Subject: AP1000 Response to Request for Additional Information (SRP 3)

RAI-SRP3.8.4-SEB1-03 R2

AP1000 TECHNICAL REPORT REVIEW

RAI Response Number: RAI-SRP3.8.4-SEB1-03
Revision: 2

Figure 3H.5-10

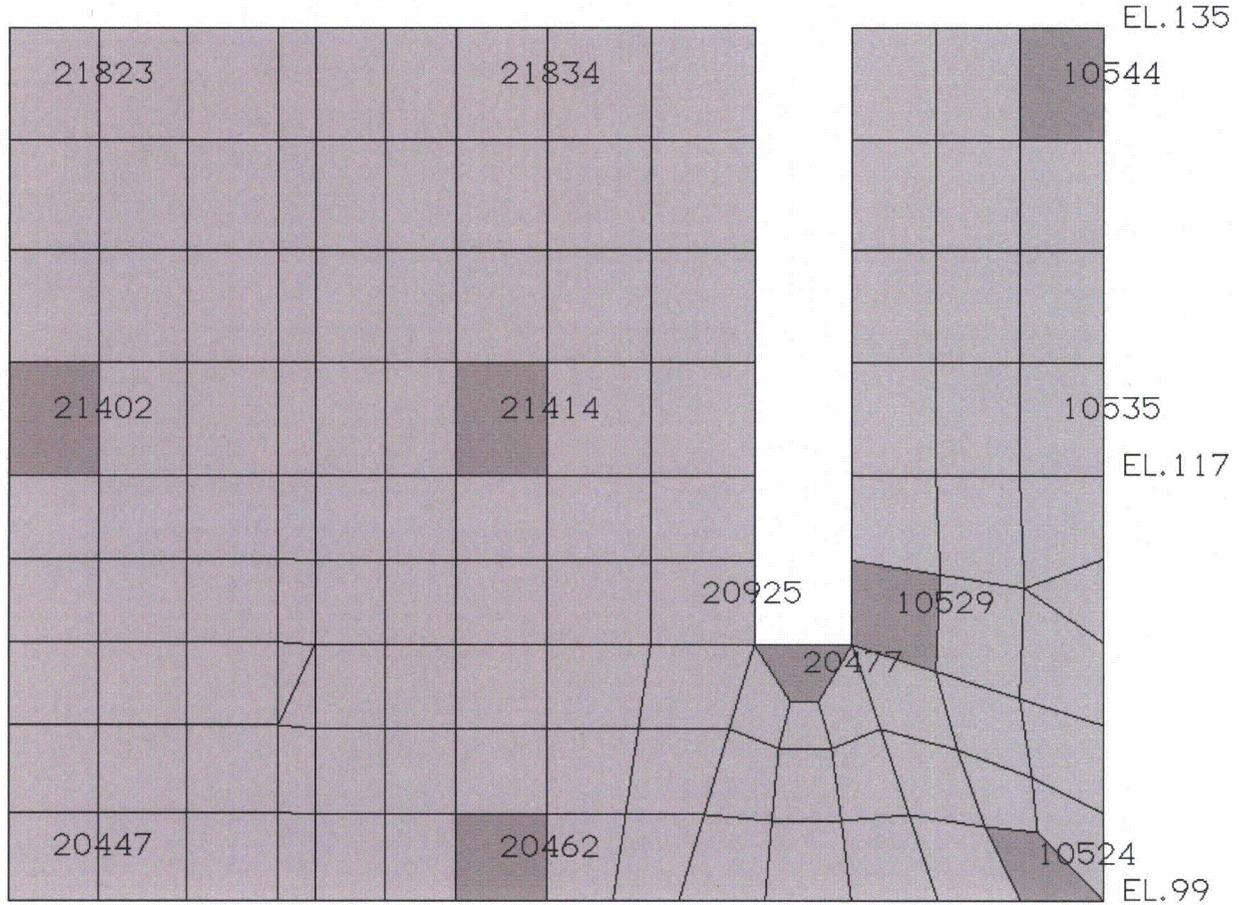
- a) DCD Section 3H.5 should discuss and refer to all of the tables that were added to the DCD;
- b) in Table 3H.5-8, include the same number and similar locations of critical sections that were provided in DCD Rev. 15;

2b. The same number of critical sections are provided in DCD Rev 18 as are provided in DCD Rev. 15. Each critical section has its own table. In DCD Revision 15 Table 3H.5-8 included information on five elements. The previous response provided information on three elements. Four additional sheets of Table 3H.5-8 will be added to the DCD for a total of seven elements to provide a design summary of spent fuel pool wall design loads, load combinations and comparisons to acceptance criteria for other elements such as element no. 21402. A revised Figure 3H.5-10 is also provided showing the location of the elements.
